CULVER AIRCRAFT CORPORATION
WICHITA, KANSAS

SERVICE MEMORANDUM

NO. 10

SUBJECT: Clearance Between Bottom of Rudder and Tab Cable Channel
Over Stabilizer.

FIGURE 1

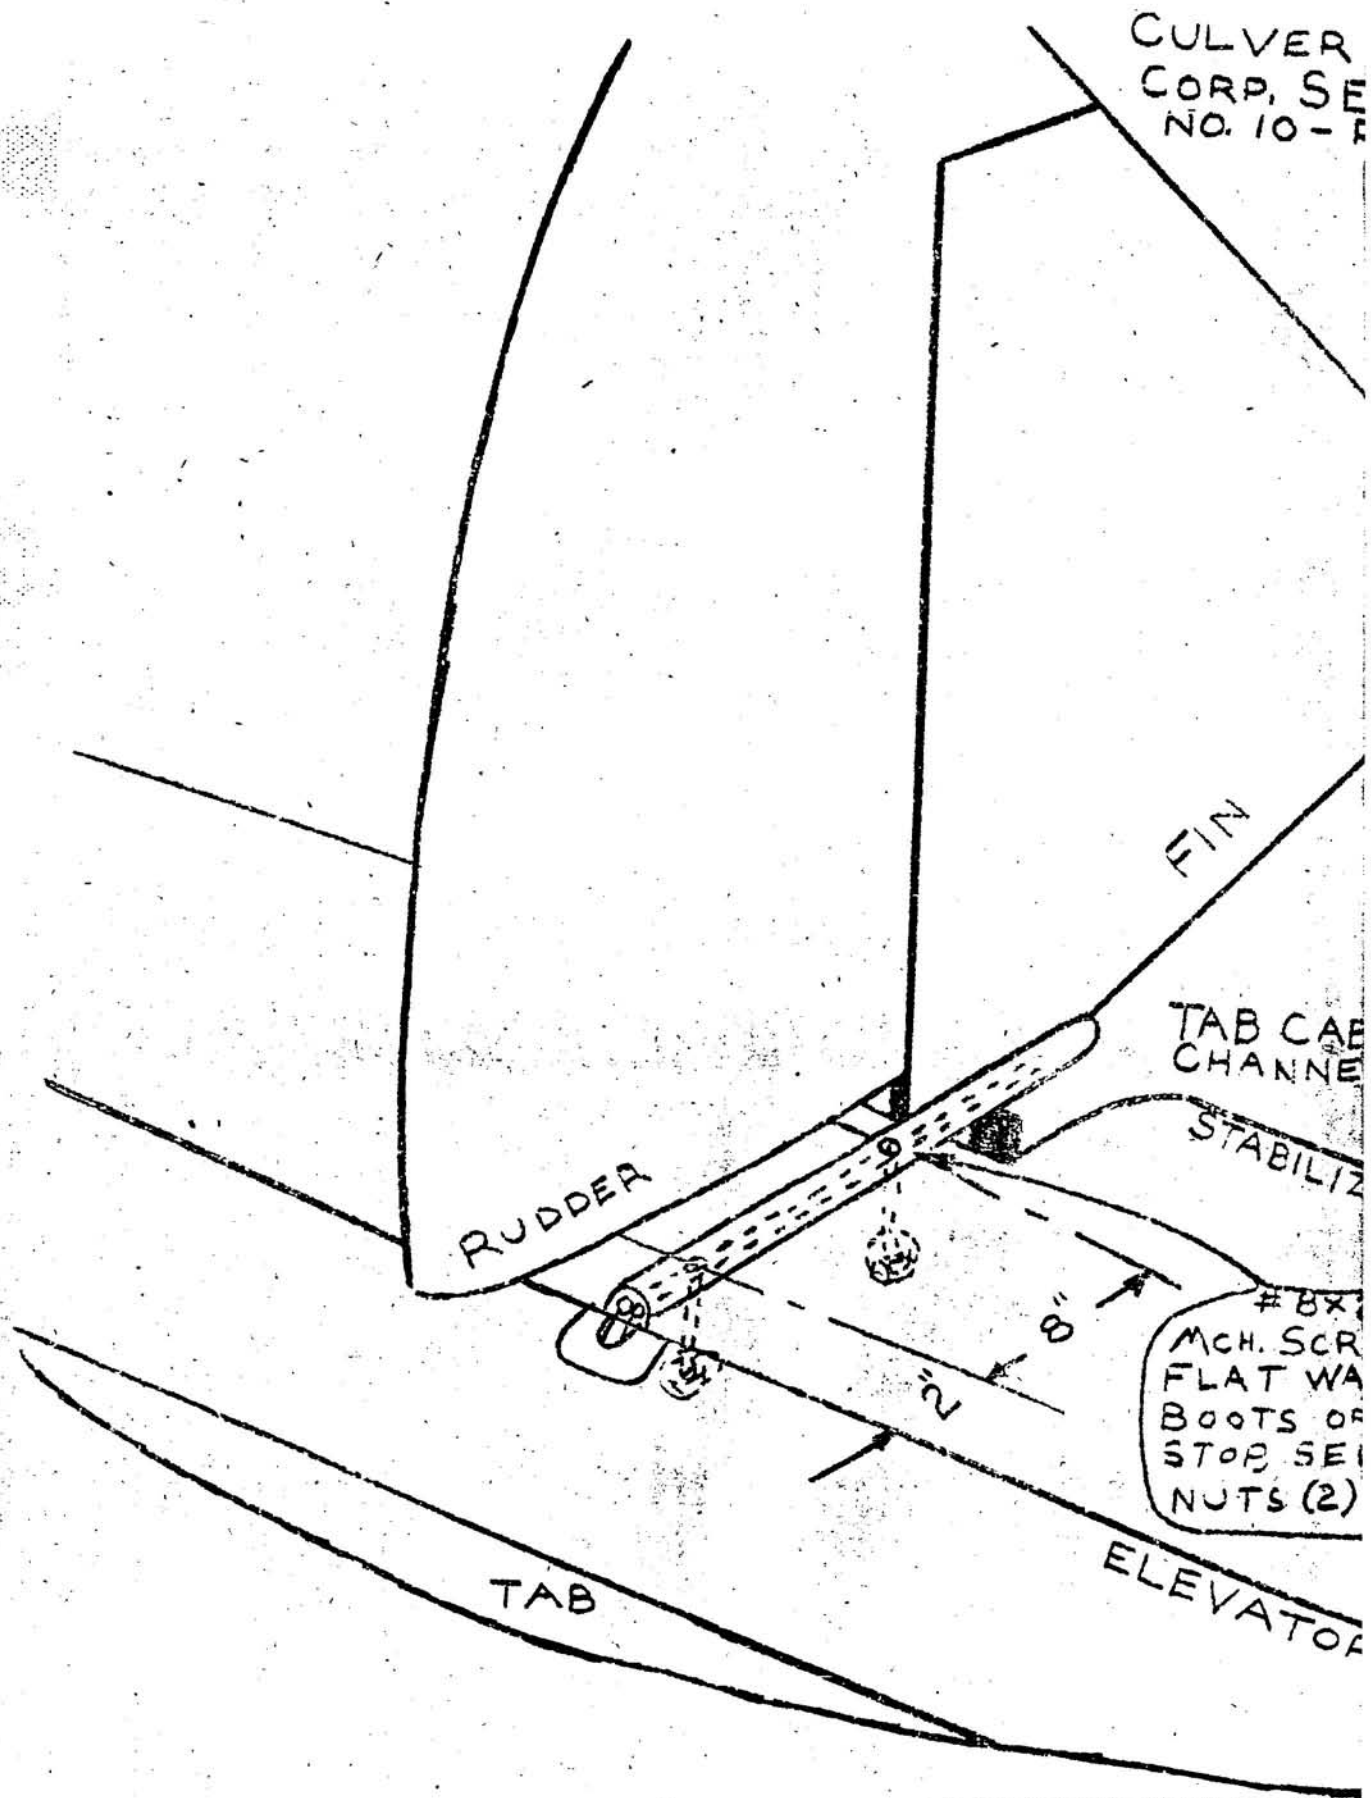
1. The tab channel on airplanes between the above serial numbers was fastened to the stabilizer by means of screws into the plywood upper surface. These screws have been known to work loose in service allowing the tab cable channel to raise up and possibly interfere with the rudder action.

2. The screws should be replaced by two machine screws, with self-locking nuts extending completely thru the stabilizer in the locations given in the accompanying diagram.

3. There should be at least 1/8 inch clearance between the bottom of the rudder and the tab channel or center elevator hinge bracket. The head of the machine screw may have to be filed down in one or two cases to get this minimum clearance.

4. If there is less than the minimum clearance, the lower panel of the rudder will have to be uncovered and the trailing edge of the bottom rib moved up to give ample clearance (preferably 1/4 inch to 3/8 inch).
